LOCATION
Manor Farm
Graveley

PROJECT NUMBER
BH23023

INTRODUCTION & BRIEF

This 'Design and Heritage' statement has been prepared by Benchmark Architects in support of a planning application for Grade II Listed home Manor Farm, Graveley formerly known as Chesfield Manor.

House & Extension- Ground Floor Plan

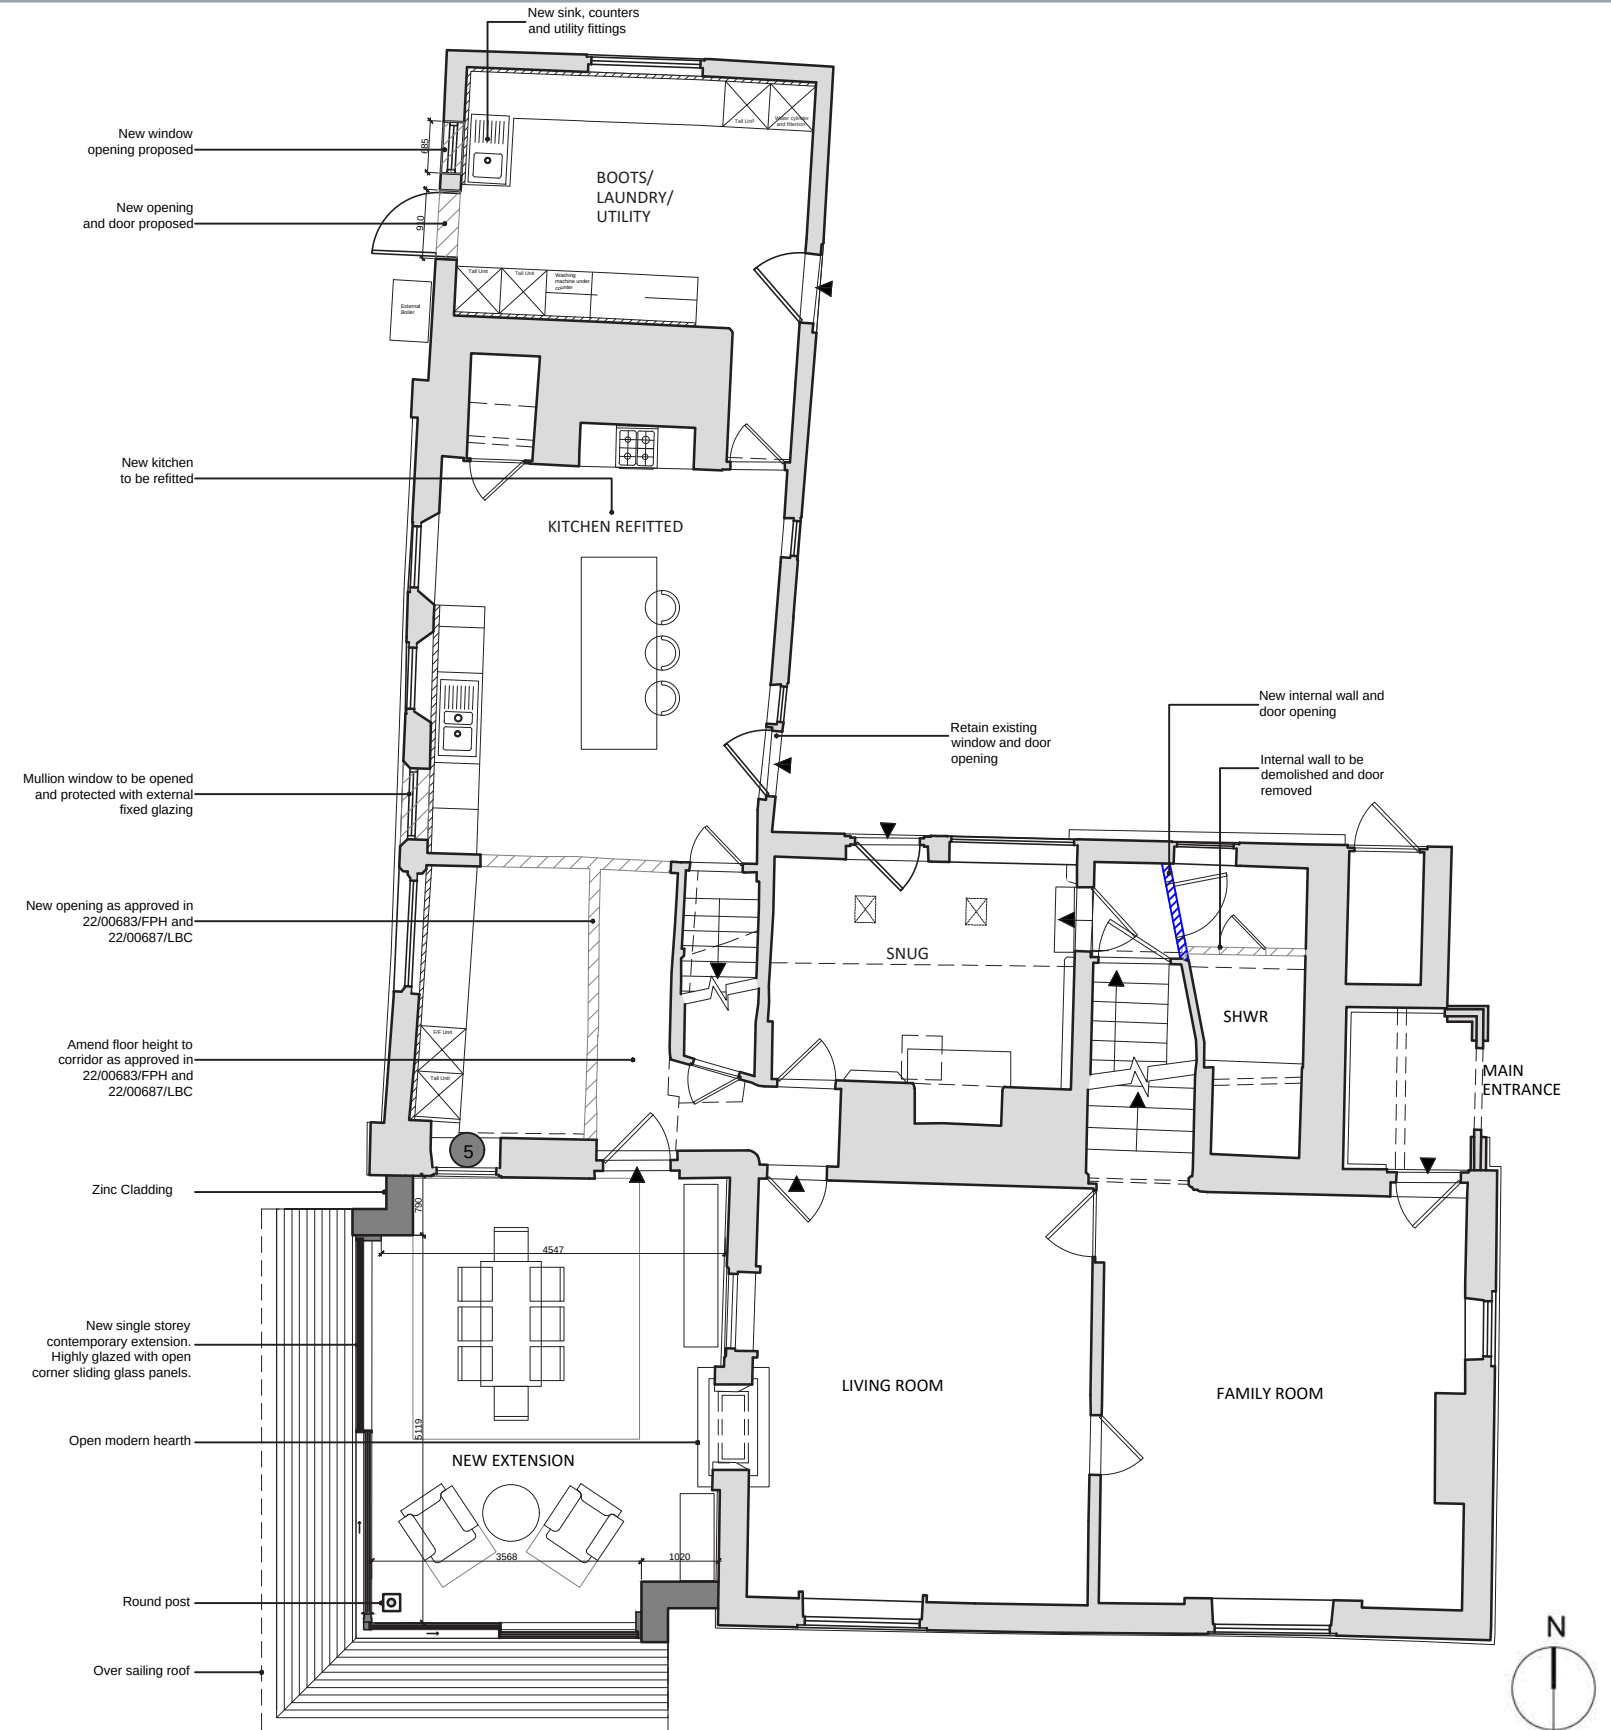
1. The proposed changes are limited to the ground floor and that the new opening from the Boots/Laundry/Utility and the removal of internal partitions in the north range and the raising of an area of floor were all permitted under the approved applications 22/00683/FPH and 22/00687/LBC.

3. Enlarging the doorway on the south elevation of the north range may prove problematic in that the pre-application submission refers to this part of the building being of high or highest significance. There is no convincing justification to enlarge this opening and so this aspect of the proposal is discouraged.

4. On the one hand the pre-submission states that the removal of the east door from kitchen is required to help clarify the confused access to the building and yet the concept proposals indicate the door and quarter-pane window alongside being replaced by a single larger window. The door is a flush-panelled type which, in my opinion, contributes positively to the building's external appearance but may well have

5. I am prepared to support the proposed opening up of the later chimney stack to create a dual accessed fireplace between the living room and proposed dining room.

6. Just to clarify matters with respect to the proposed French doors to the Boots/Laundry/Utility. Whilst it is correct to say that the opening was approved in 2022, this opening would have sat behind and therefore screened by a plant room addition. In my opinion, whilst French doors may not be objectionable, there is a case to suggest that with this being the service end of the property it would seem more appropriate to encourage a single service door as opposed to formal French doors. It was also brought to the officer's attention that the applicant would like to install a new boiler on the hard standing area here where the extension was to be built (unobjectionable). Although it is suggested that the base of the unimplemented extension becomes effectively a patio, the combination of boiler and access to Boots/Laundry/Utility is such that it arguably does not lend itself to the best position for a patio and French doors.

The proposed changes on the ground floor remain as above. In addition to these changes, a new wall with door opening is proposed for the shower room on ground floor. On the first floor, a new wall with a door opening is proposed to create a corridor that separates the bedroom from general circulation.

The design proposal keeps the existing door and opening as existing. This door will lead into the newly proposed extension.

The design proposes to retain the window and door opening as existing, however the existing door and frame to the kitchen is cracked and warped, it will be replaced by new door and frame of similar style. The existing softwood window is in poor condition which will be replaced by a new hardwood window of similar style.

The proposal of the dual accessed fireplace between the living room and extension will remain.

The design proposal shows new door and a window opening instead of the French doors to the Boots/Laundry/Utility. The previously proposed extension at this side of the house is not to be realized, however as per the applicant's requirement an external boiler will be placed near the Boots/Laundry/Utility space on the outside.

- Wall partly removed to create a new door and a window opening for the utility space.
- Internal wall leading into the shower room to be removed and create a new wall with a door opening.

House & Extension - First Floor Plan

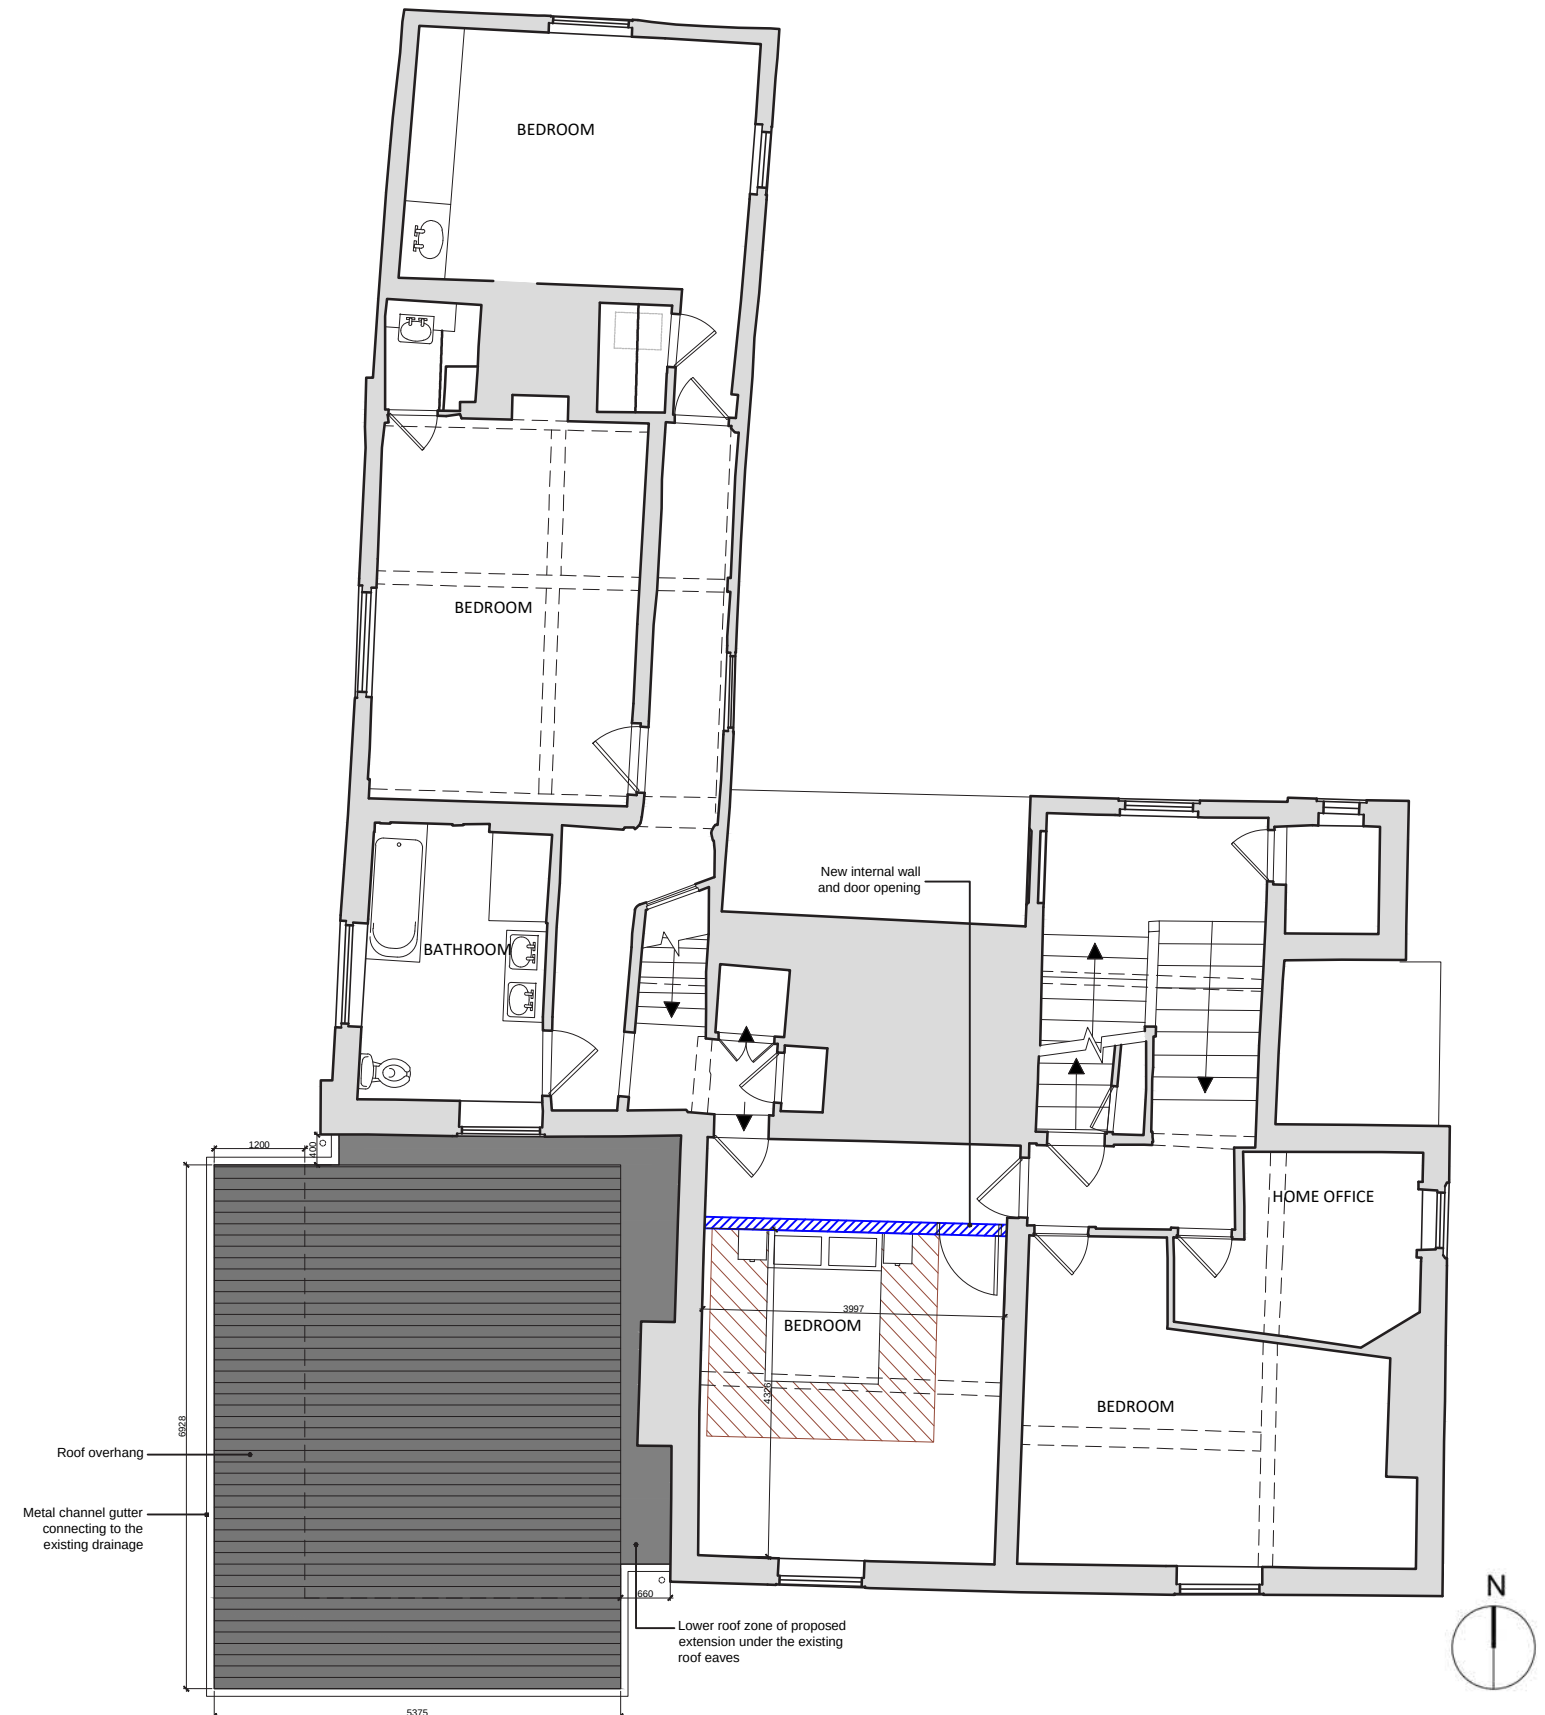
2. As stated in the submission, 'the extension will be contemporary with a low-pitched black zinc roof and a high level of glazing. The glazing will project beyond the main structure of the extension to ensure that views into the garden areas and to the church ruins are achieved. The overhanging roof will minimise the risk of overheating'. Whilst I raise no objection to the choice of materials or the amount of glazing, the substantial roof projection will impact upon the reading of the south and west facing façades considered as possessing high and highest significance respectively.

3. I place minimal weight to the aspiration of being able to enjoy views of the walled garden, neighbouring countryside, and the remains of the Church of St. Etheldreda (grade II* and a scheduled monument). The question is whether the roof projection would be a modest, polite intrusion or a more severe interruption to the existing building line. In my view, the projection is the most challenging aspect of the design and there may be other measures that could compensate for any perceived overheating or maybe simply setting the extension further back from the front building line on both sides.

The revised proposal has reduced this overhang/projecting eaves. We do not feel that it will impact significantly on the south and west façades.

Similar to the concern above we feel the projection of the roof of proposed extension is not a severe change to the existing building line.

- New internal wall proposed to create a separation between the corridor and the bedroom.

Outbuildings - Ground Floor Plan

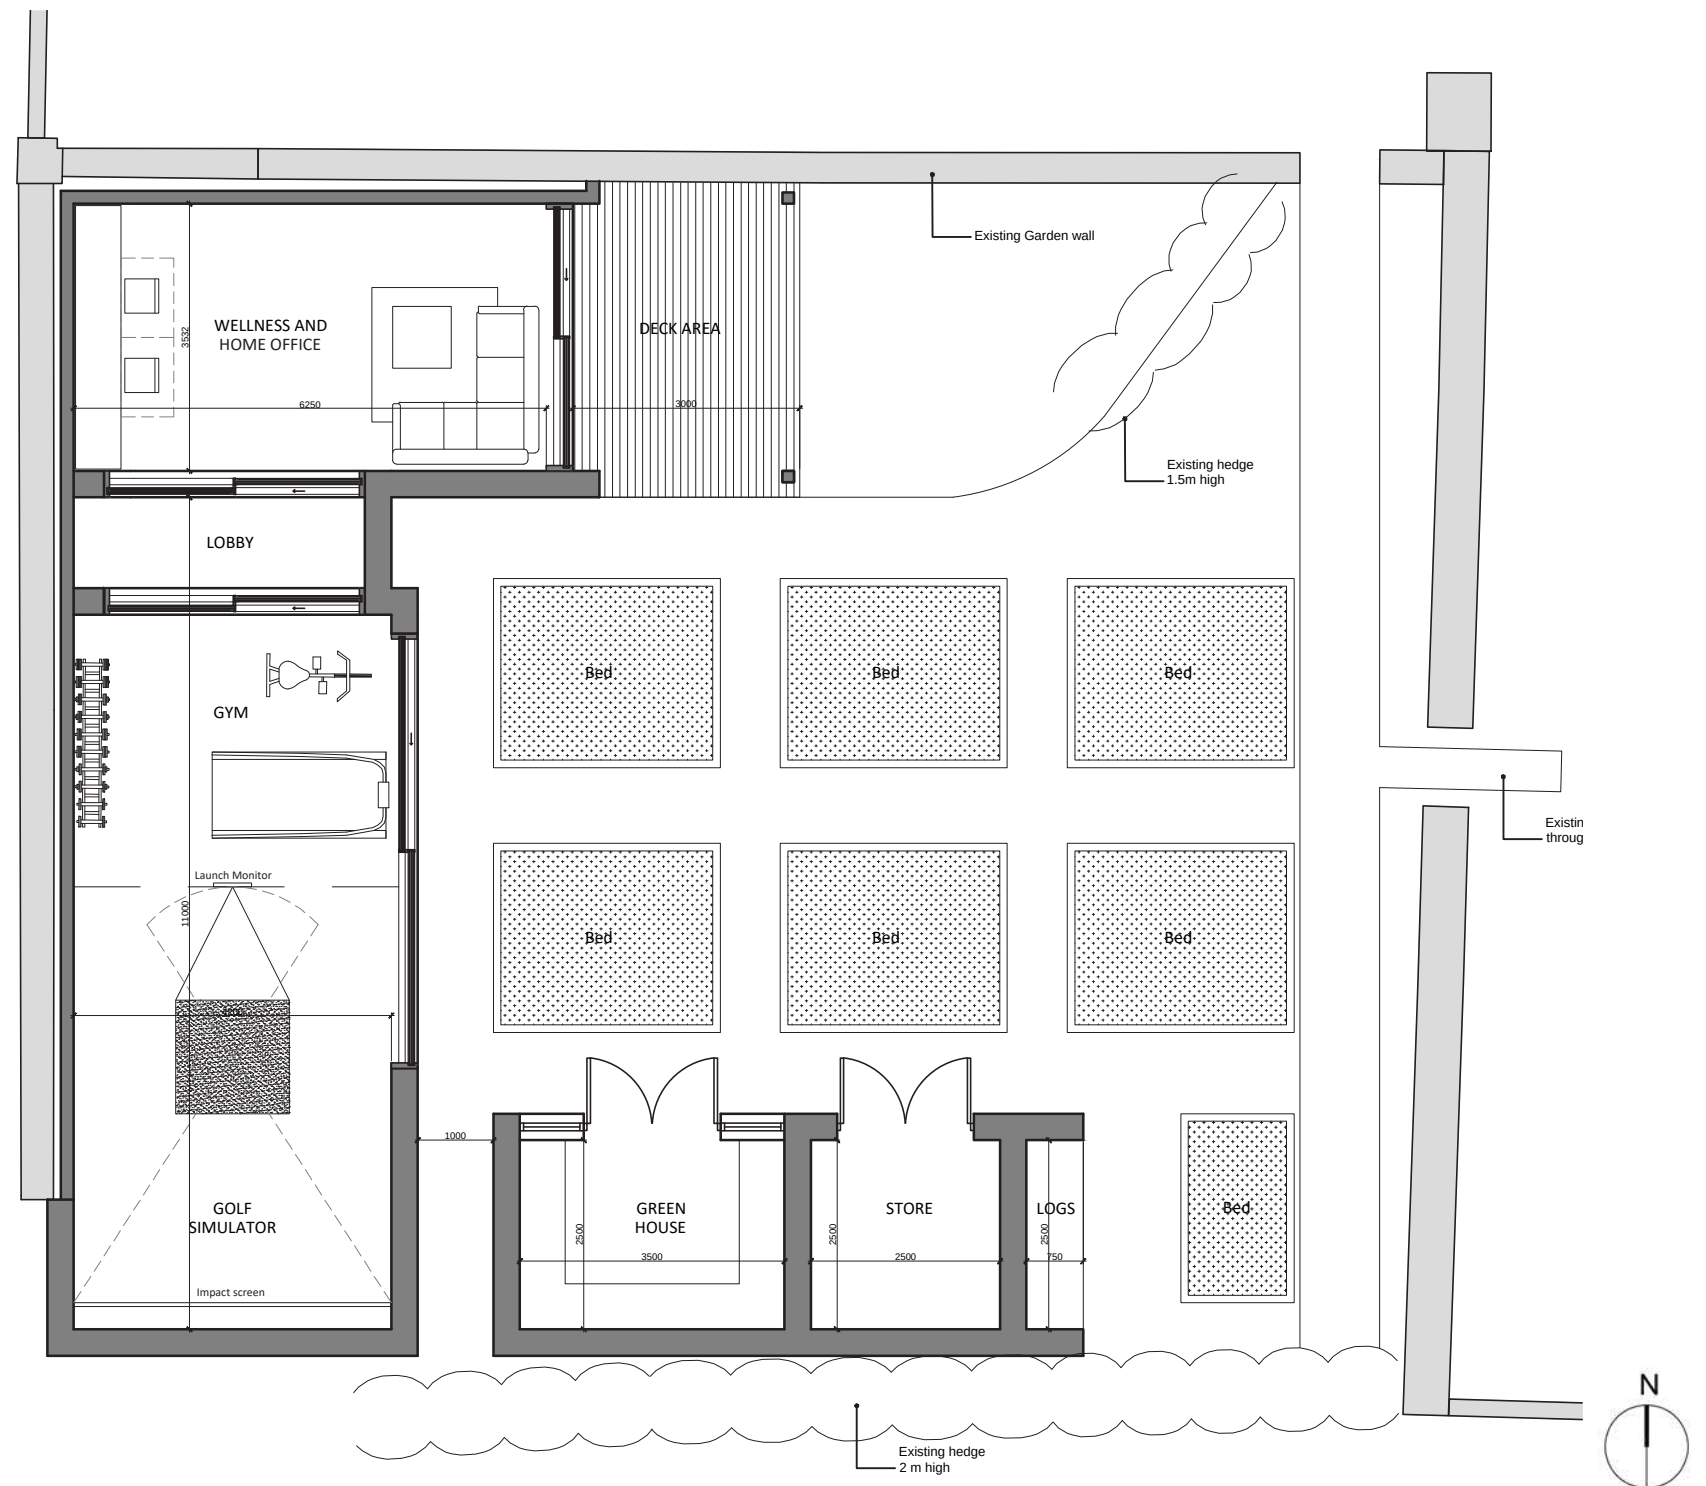
1. At page 5 of the pre-application submission, it states the following: 'The only outbuildings to service the main house is a modern single garage built abutting the listed wall. This can no longer be accessed from the driveway and is too small for modern cars. This is currently used as a temporary home-gym. To the south-west the Kitchen Garden contains early to late C20th garden buildings along the western boundary'. This aspect of the proposal is arguably more contentious than the extension to the main house. The OS map regression below identifies the site during the late C19 and early C20 and the walled garden with buildings is clearly shown. Looking at the planning history and particularly photos on appn ref:00/01123/1LB, the outbuildings against the west wall of the walled vegetable garden show that the structures were in poor condition. Other photos show a chimney stack that would have served a building in the north-east corner of this enclosure. What we see today is the implemented scheme approved in 2001. It is fair to say that the softwood framing to the conservatory/greenhouse has not stood up particularly well to weathering in the last 23 years. Having said that, the scheme makes a positive contribution to the walled garden and to the wider setting of Manor Farmhouse. Contextually it is highly appropriate. Whilst I probably cannot resist the demolition of C21 structures, the question this raises is would the proposal make an equally or better contribution to Manor Farmhouse's setting?

2. The weatherboarding and large glazed areas do not have the architectural vocabulary of buildings expected to be found in a walled garden setting. Additionally, whilst I appreciate the benefits of introducing solar PV to the roof, this will also instil the perception that

3. The justification of the use of the new building is not particularly compelling although I am empathetic to a home office use. I am also mindful that as the land in the ownership of Manor Farm has diminished over recent years, so the opportunity to provide such facilities outside of the residential garden grounds cannot be realised.

We feel that the proposed garden outbuildings will make a positive contribution to the Manor Farmhouse as it will enhance the quality of the garden space by the rebuilding of structures in the kitchen garden.

In the design proposal we are not proposing PV panels on the roofs to maintain the domestic nature of the proposed spaces.

In addition to the wellness/home office space with an extended deck space, a green house along with a store space is also proposed. A space to accommodate a golf simulator and gym is also proposed.
